DOCUMENT CHANGE REQUEST

DCR number 332	Changes required for: N/A	Originator: S Jeffery
Date: 2007/04/17	Date sent: 2007/04/17	Organisation: ESA/ESTEC
Status: IMPLEMENTED

Title:	Transistors Matched Dual PNP, based on types 2N3810 and 2N3811		
Number:	5207/005	Issue:	1

ESCC Detail Specification No. 5207/005

1.6.1 Metal Can Package (TO-78) - 6 lead

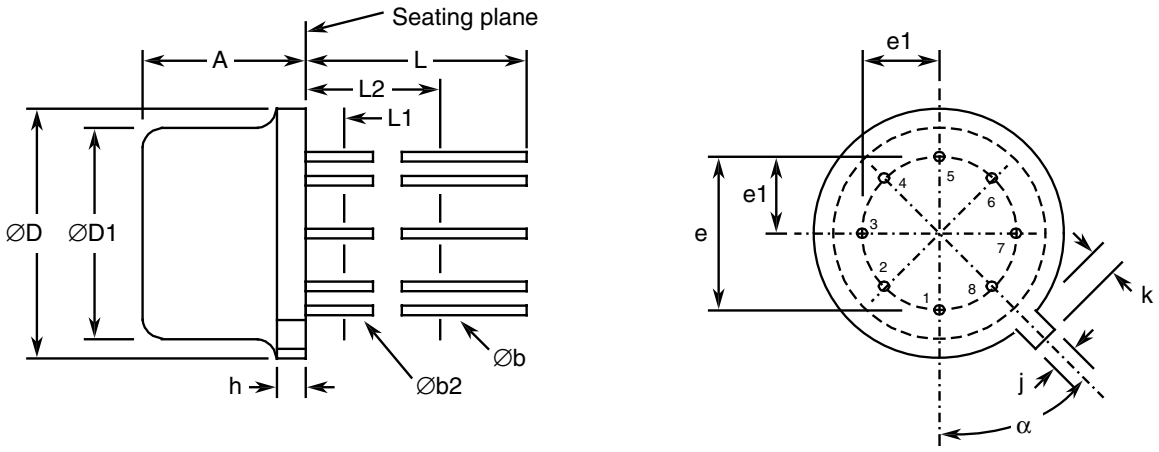
7. Para. 4.3.2 Weight requirements moved to Component Type Variants table.
8. Figure 2 re-named "Physical Dimensions and Terminal Identification"; Figure 2(a) amended to reflect the TO-78 package currently supplied; Figure 2(b) amended to reflect the CCP package currently supplied.

1.7 FUNCTIONAL DIAGRAM

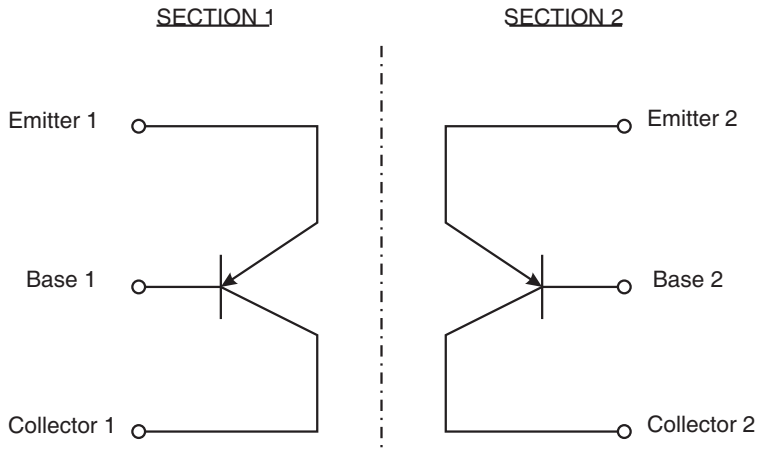
9. Figure 3 Functional Diagram amended and Notes added.

NOTES:
1. For TO-78, the case is not connected to any lead.
2. For CCP, the lid is not connected to any terminal.
